# Access Compliance Report

## Public Rights-of-Way

### (Curb Ramps)

Intersection ID: 15725	Main Street: CLANTON_RD	Cross Street: S_TRYON_ST	Location: NE
ADA ID: B497FA830F74	Ramp Type: Perp	Initial Pass/Fail: Fail	Overall Compliance: No
Severity Score: 25			
Codes/Mitigation Info/Possible Solution		Field Measurements/Component Compliance

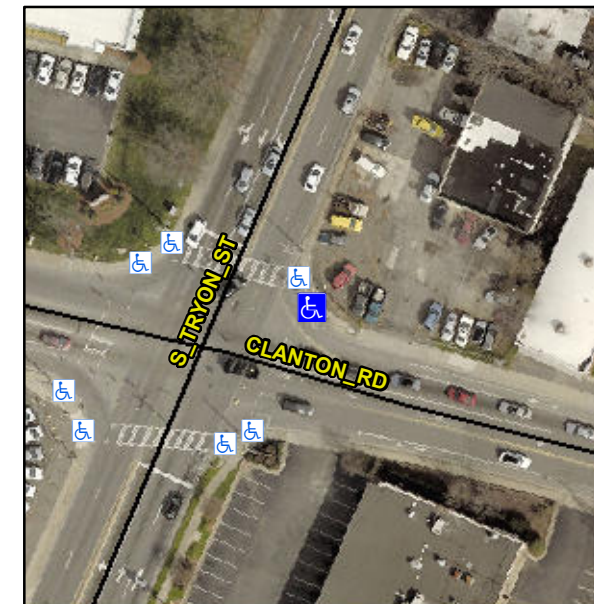
**Not Found, R304.2.2, R304.5.3**

Compliance	Description	Data	Compliance	Description	Data
N/A	Ramp Length (in)	61.0	No	Ramp Slope (%)	9.0
Yes	Ramp Width (in)	48.0	No	Ramp XSlope (%)	5.1
N/A	Flare Type LT	N/A	N/A	Flare Type RT	N/A
N/A	Flare Slope LT (%)	N/A	N/A	Flare Slope RT (%)	N/A
N/A	Flare Traversable LT?	N/A	N/A	Flare Traversable RT?	N/A
N/A	Landing Length (in)	N/A	N/A	DWS Provided?	N/A
N/A	Landing Width (in)	N/A	N/A	DWS Contrast?	N/A
N/A	Landing Slope (%)	N/A	N/A	DWS Length (in)	N/A
N/A	Landing X Slope (%)	N/A	N/A	DWS Full Width?	N/A
N/A	Landing Curb? (Y/N)	N/A	N/A	DWS Offset (in)	N/A
N/A	Shared Landing?	N/A			
N/A	Gutter Ponding?	N/A	N/A	Gutter Slope (%)	N/A
N/A	Gutter Lip Ht (in)	N/A	N/A	Gutter X Slope (%)	N/A
N/A	Painted X Walk1?	Yes	N/A	Painted X Walk2?	N/A
	X Walk 1 Direction	To SW		X Walk 2 Direction	N/A
N/A	X Walk 1 Width (in)	111.0	N/A	X Walk 2 Width (in)	N/A
	X Walk 1 Slope (%)	6.4		X Walk 2 Slope (%)	N/A
	X Walk 1 X Slope (%)	1.5		X Walk 2 X Slope (%)	N/A

**Remove & Replace Entire Ramp.**
